PREVOST

WARRANTY BULLETIN

WB14-03

DATE :	APRIL 2014	SECTION :	06 - Electrical
EXPIRATION:	APRIL 2016		
SUBJECT :	BATTERIES BOX COVER REPLACEMENT

Fig.4 Correctly positionned drilling template shown on the left.

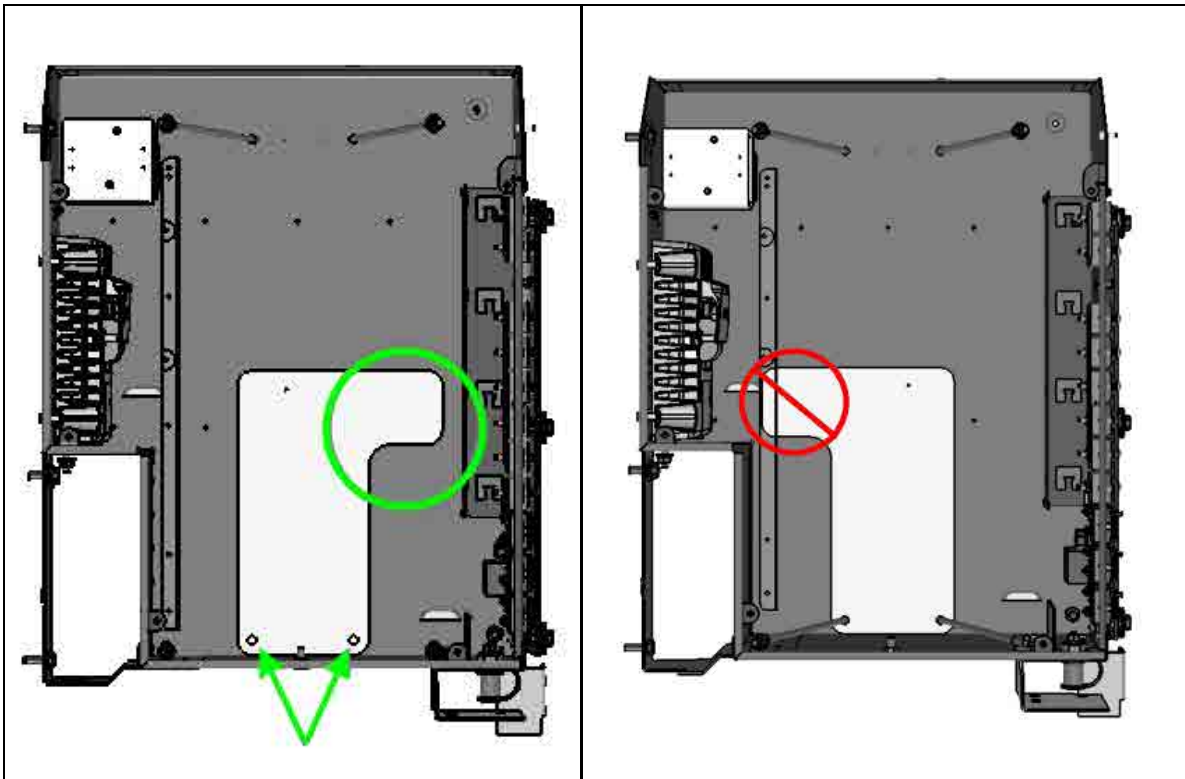
6. Position the drilling template at the bottom of the battery box using the hold-down rods holes (Fig.4).

NOTE: The drilling template is designed with a foolproof tab and can not be installed backward.

Fig.5 Drilling position viewed from top (Left) and bottom (Right) of the vehicle.

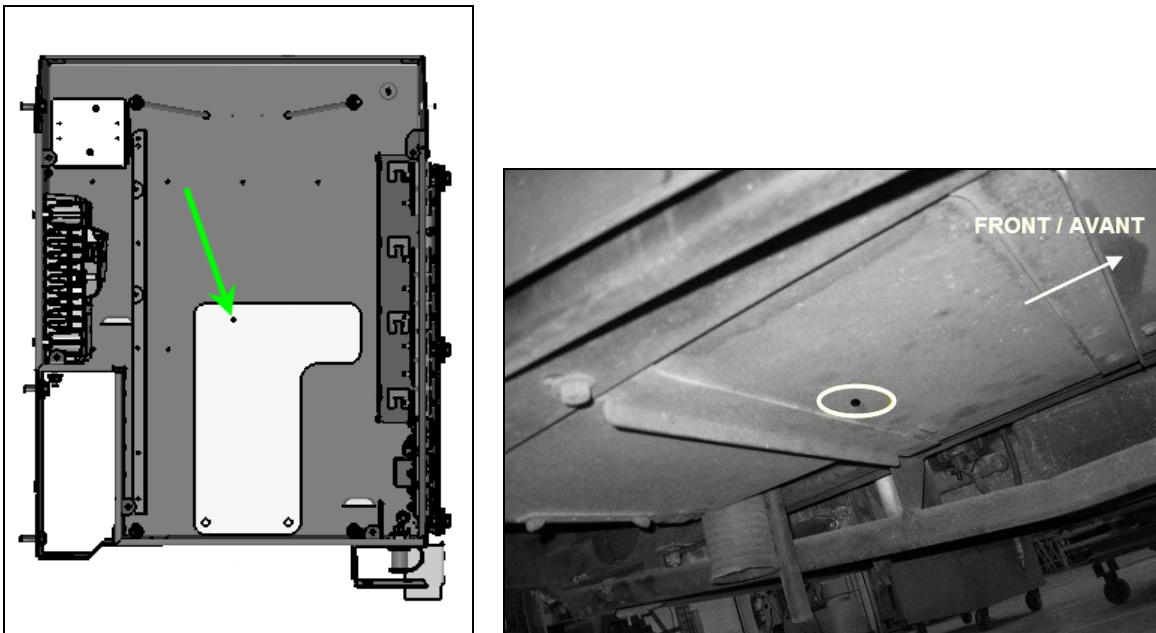
7. With the drilling template installed, drill through the box bottom using a 3/8po or 10mm drill bit (Fig.5).

Fig.6 Battery box cover rod correct positioning.

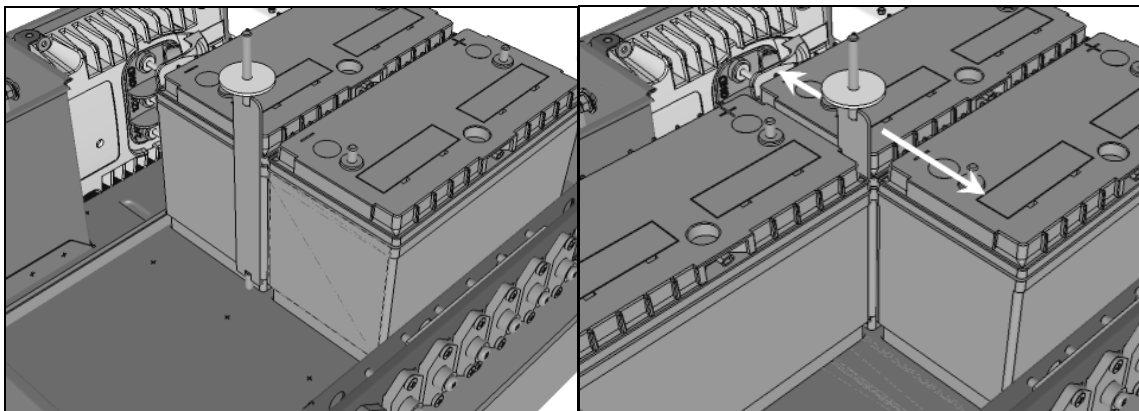
8. Remove the drilling template.
9. Install the new battery box cover rod (068867) at the bottom of the box. From the vehicle underside, hand tight the rod using the supplied 3-8-16 hex nut (500702) and the flat washer (068704).

NOTE: The rod flat section must be positioned along the width of the box (Fig.6)

10. With the rod correctly positioned, torque down the 3/8-16 hex nut to 30 ft-lb (40 Nm).
11. Reinstall the four (4) bars hold-down rods (Fig.3).
12. Reinstall the batteries following Fig.7 bellow.

Fig.9 New cover installed

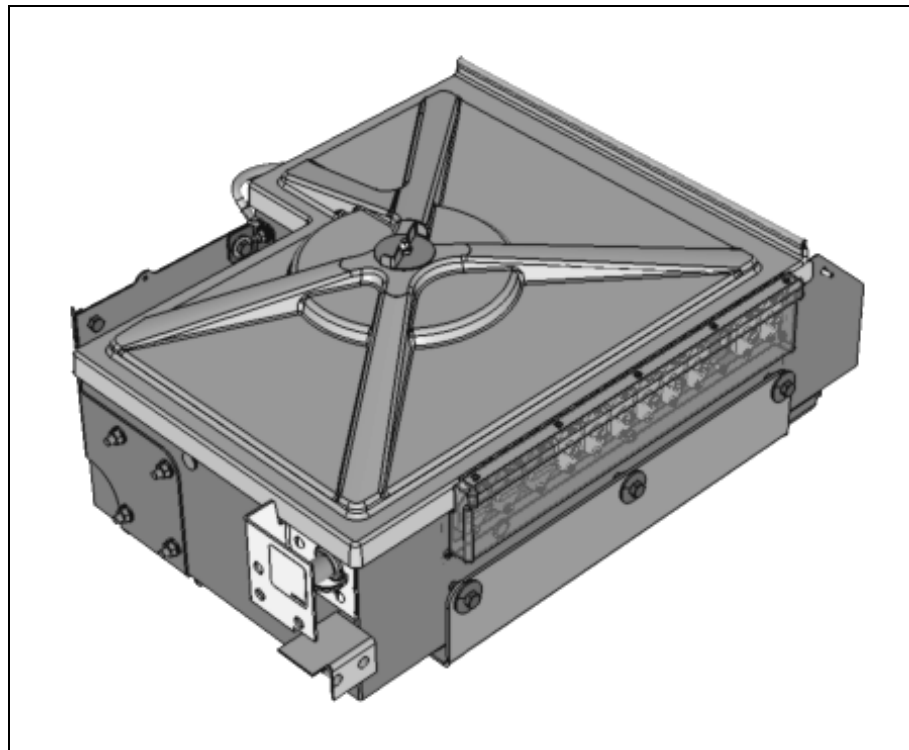
15. Install and tighten the new battery box cover (068858) using the provided wing nut (068765), check for proper fitting of the assembly (Fig.9).
